SERVICE INFORMATION NO. SI D4-122

All DA 40 D aircraft equipped with GARMIN G1000 System

GARMIN Service Advisory No.: 0908 Revision A

SUBJECT: Garmin Integrated Flight Deck systems may display a DME failure

Figure 1. DME Windows with Red-X

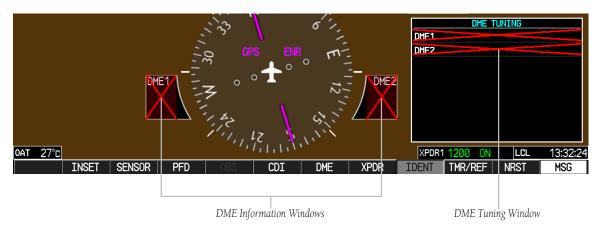
Garmin Integrated Flight Deck systems with GDU Software v8.20 through v9.01 and equipped with the Honeywell KN63 DME may display a Red-X in the DME Information Window and the DME TUNING Window (Figure 1) upon power-up if the Honeywell KN63 DME is not receiving a valid DME signal. The Red-X is removed only after a valid DME signal is received, or after removing power (for approximately 5 seconds) and then restoring power to the KN63.

- 1) Remove power (for approximately 5 seconds) and then restore power to the KN63 DME. This procedure may need to be repeated in the unlikely event that the initial cycling of power does not clear the Red-X.
- 2) The tuned DME station becomes valid and gains reception. This can be accomplished if NAV1 or NAV2 was selected in the DME TUNING Window prior to the power-up DME failure indication, the Red-X condition can be cleared by tuning the appropriate NAV radio to a valid DME station within signal reception for the area.

GDU Software versions 9.02 and above, have corrected this issue.
